040-1194-00

TANGENTIAL NOISE REDUCTION

For TEKTRONIX® A6902A Isolators

Serial Numbers B010100 - Up

Fig. 1 - Toroid Shield Installation

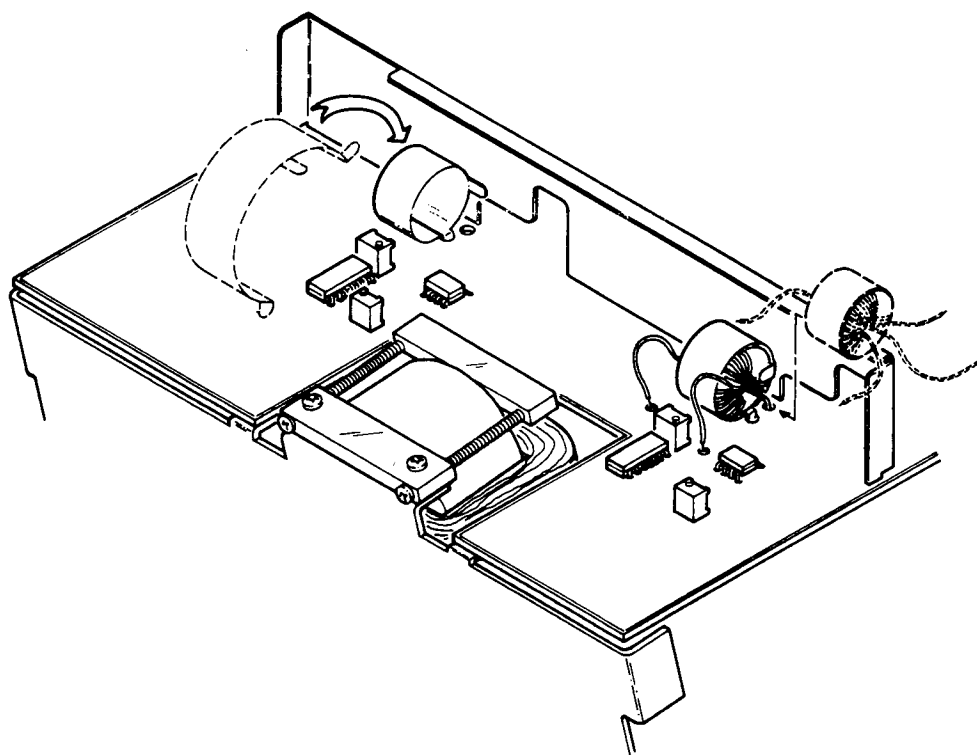
This kit provides parts and instructions to reduce tangential noise and therefore improve product performance. The kit consists of two metal shields which are added to T2250 and T2750.

- () 6. After first desoldering necessary wires (note color code and locations), wrap the included toroid shields around the signal transformers, T2250 and T2750 (refer to Fig. 1 for the shield installation portion of this procedure).

- () 7. Insert the square tab into the square slot and bend it over toward the edge of the shield.
- () 8. Bend the edge of the shield over so the small tabs overlap.

- () 9. Bend the large tabs down to secure the transformer within the shield (do not damage the wire insulation).

- () 11. Insert the tabs through the Main circuit board holes most distant from barrier shield.
- () 12. Bend tab pairs in opposite directions, making contact with the Main circuit board.
- () 13. Solder the tabs in place.
- () 14. Resolder all wires earlier desoldered.
- () 15. Clean solder flux from the circuit board and reassemble the instrument.
- () 16. Refer to the Service Manual and verify performance.
- () 17. Remove the protective backing from the include 040-kit label and place it on a clean dry area of the instrument near the serial number tag.
- () 18. Add the part numbering information to the Mechanical Parts List of the Service Manual.
